97-08-22

## Model 51/55

## Air filter and air filter holder

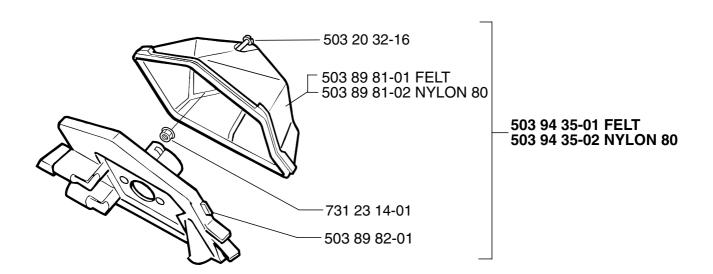
The air filter holder has been modified to improve the function of the air filter and to ensure a secure fitting. The air filter is now secured by a screw.

It's possible to fit the new air filter holder with the new air filter on older saws.

Introduced from serial number: 7151551
